Response to Comment Letter O2

Delano & Delano on Behalf of Escondido Country Club Homeowners Organization (ECCHO)
Everett DeLano
August 18, 2017

Figure 1. Portions of the 2000 U.S.G.S. Escondido and San Marcos 7.5' Quadrangles Showing Blue-Line Watercourses and Waters of the US (WOUS) and Waters of the State (WOS) The Villages - Escondido Country Club

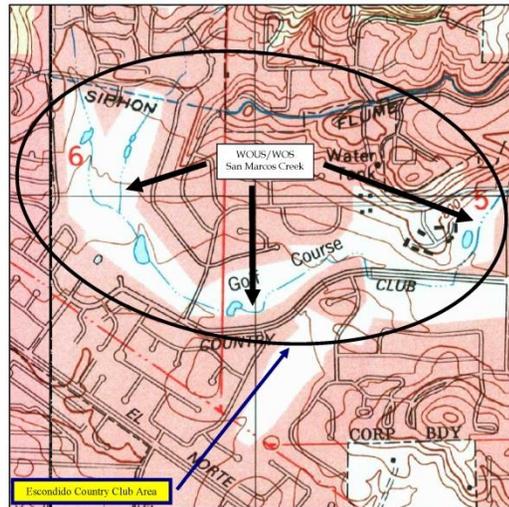
ANNOTATION: San Marcos Creek, shown above as a U.S.G.S. blue-line watercourse, enters the Project site via large culverts on the north and east. The creek then crosses the Project site in a modified form before exiting the site at the south into large culverts which eventually drain into Batiquitos Lagoon and the Pacific Ocean.

Figure 1. Portion of the Historic 1897 U.S.G.S. Escondido, California Quadrangle
 Showing Blue-Line Watercourses and Waters of the US (WOUS) and Waters of the State (WOS)
 The Villages - Escondido Country Club

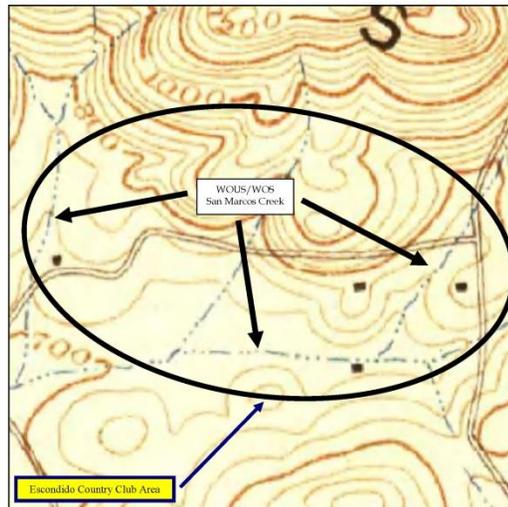
ANNOTATION: San Marcos Creek is shown above in its natural configuration in 1893. This creek has been mapped as a U.S.G.S. blue-line watercourse for many decades. Although the surrounding lands were significantly modified for agricultural use by mid century, then converted to residential use in the second half of the 20th century, the creek continues to essentially follow its historic flowage pattern, crosses the Project site and then exiting the site into large culverts which eventually drain into Batiquitos Lagoon and the Pacific Ocean.

Figure 2. U.S.G.S. "Blue-Line" Watercourses - Escondido Country Club Golf Course

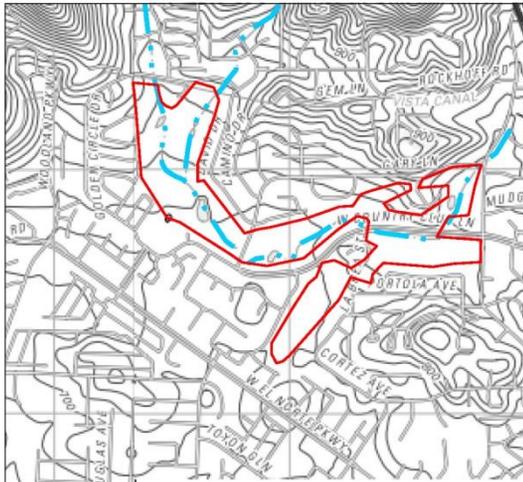
As mentioned, the site supports several watercourses. These are illustrated in Figure 2. Some of these are well-defined, supporting a diversity of native species. The well-defined drainages are generally located along the edges of the course. More poorly-defined watercourses run through the middle areas of the golf course where they have been significantly modified and realigned. These are actively manicured as part of the golf play area. The native plants associated with these central drainage areas are lower and support a mixture of upland and wetland species. Also present are several ponds that support wildlife, including raptors such as Osprey (*Pandion haliaetus*) as well as drinking areas for local small mammals. Most of the areas mapped in Figure 2 qualify as jurisdictional wetlands, subject to regulation by various state and federal authorities, including the California Department of Fish and Wildlife, the U.S. Army Corps of Engineers, the California Regional Water Quality Control Board, and others. All of these agencies

Figure 4. Potential Habitat Creation Areas – Escondido Country Club Golf Course

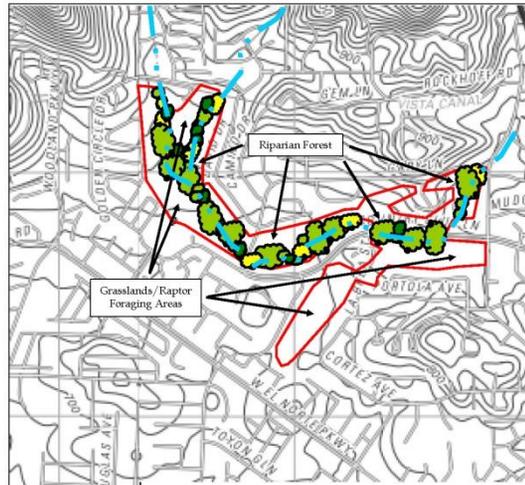
One alternative to housing that would avoid the losses of wetlands and upland values associated with this large, open property would be the development of a formal mitigation bank to restore the historical drainages and provide open, foraging habitat for local raptors. Figure 3 illustrates this in concept. Turf could be removed and a well-developed riparian forest could be established in its place. This would improve water quality, including groundwater, and provide a very significant source of income for the property owners. It would also be consistent with the City's designation of this property as open space.
